Accessibility Survey

City of Downey Blandwood Road - Elmont Avenue to Elston Avenue

Date of Inspection
6/21/2017

Disability Access Consultants

North Side @ 33.966257941494, -118.120045959949

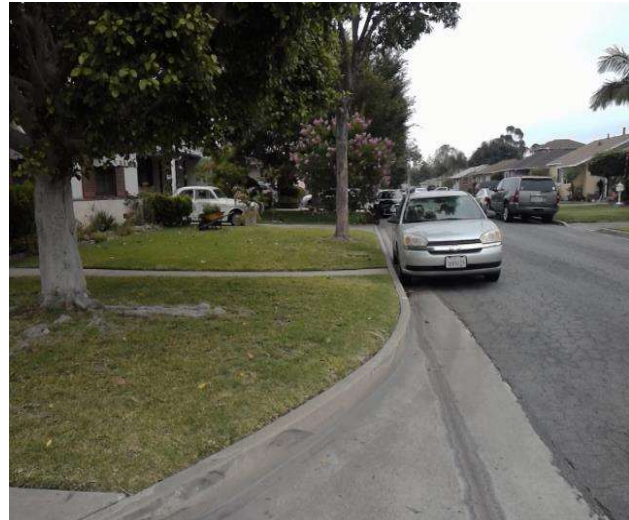
No sidewalk exists at the location.

On-Site Finding Not Found

No action necessary until a sidewalk is provided.

Change in Level West of Pico Vista Road @ 33.947734446968, -118.099041581154

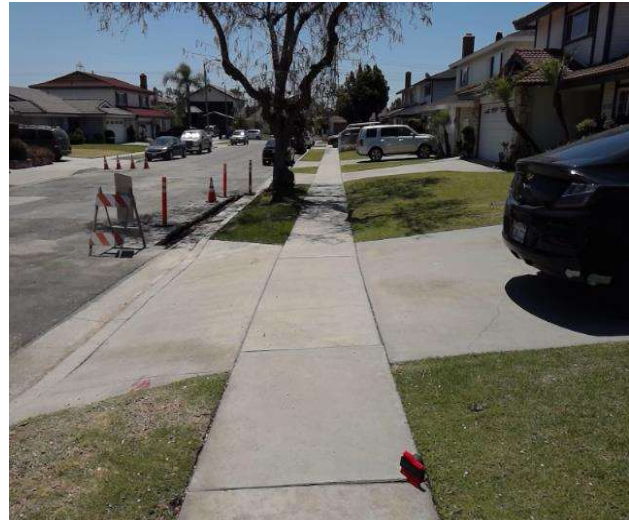
There is a change in elevation greater than recommended value.

On-Site Finding 0.62 inches

Ensure that the change in elevation is within the recommended value.

Recommendation Up to 0.25 inches
